**TOWN OF FAIRFAX  
STAFF REPORT  
Department of Planning and Building Services**

**68 CYPRESS DRIVE**

**A Resolution of The Fairfax Planning Commission Approving Application No. 16-38 for a Design Review Permit for a 50% Remodel of an Existing Residence at 68 Cypress Drive**

### FIRE DEPARTMENT PLAN REVIEW

Veg Mgmt  
Plan for  
PRB

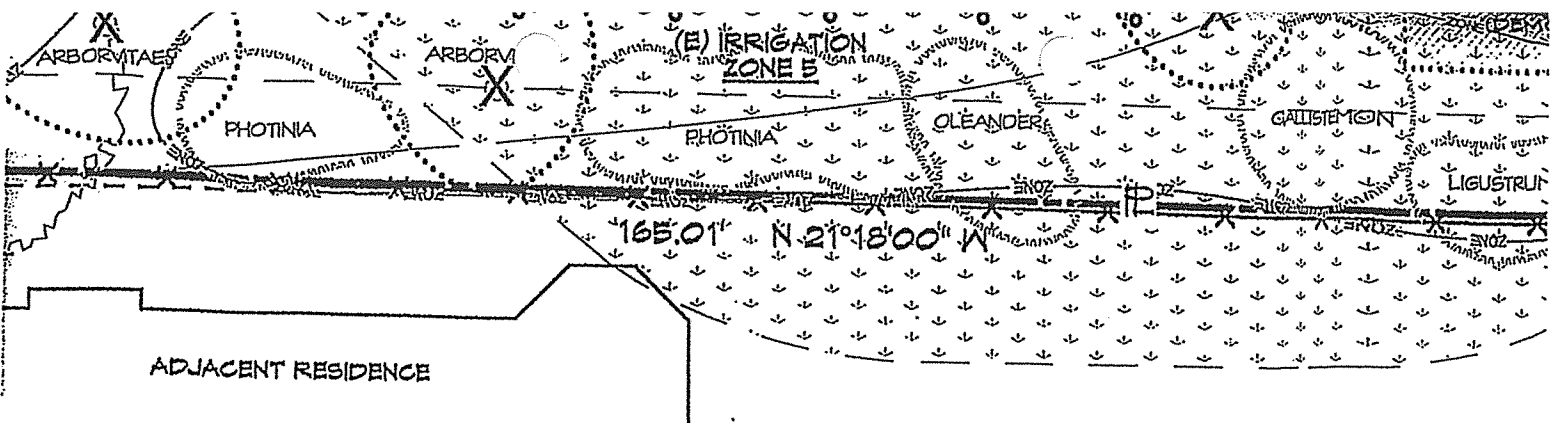
The Vegetation Management Plan submitted for review by the Ross Valley Fire Department is approved with the following conditions:

Please do not remove any tree that requires a permit without first securing such permit.

Please note that all vegetation within the 30 foot zone shall be irrigated. Seasonal grasses within the 30 foot zone are not permitted unless regularly irrigated. If not kept as green grass the area shall be covered in a weed barrier which should be covered in a layer of mulch.

Every effort shall be taken to ensure erosion control efforts are in compliance with standards established by Town regulations.

The approved plan is to last the life of the property. Any changes to the plan now or in the future will require Fire Department review. It is recommended that if the applicant has plans to landscape in the future that those plans be intermingled into this plan.

Vegetation shall be maintained to ensure address numbers are visible from both angles of approach.
